STERLING RANCH EAST FILING NO. 3

CONSTRUCTION PLANS

JANUARY 2025

STERLING RANCH EAST
FILING NO. 3
CONSTRUCTION PLANS
TITLE SHEET

EMERGENCY SPILLWAY PROFILE

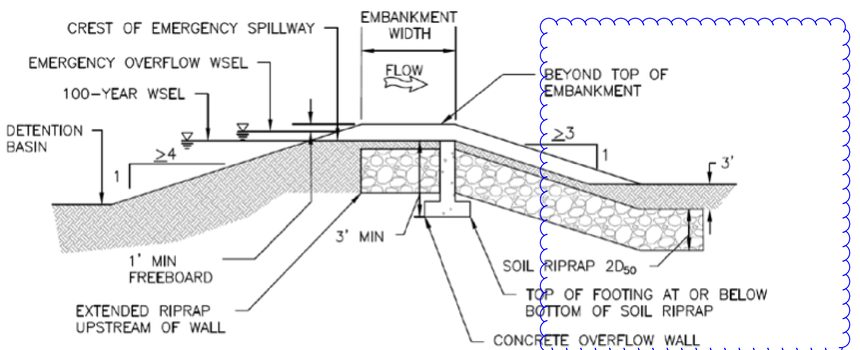
This needs a section detail. Spillway needs to extend below the toe and nothing shows this. Is there a concrete overflow wall?
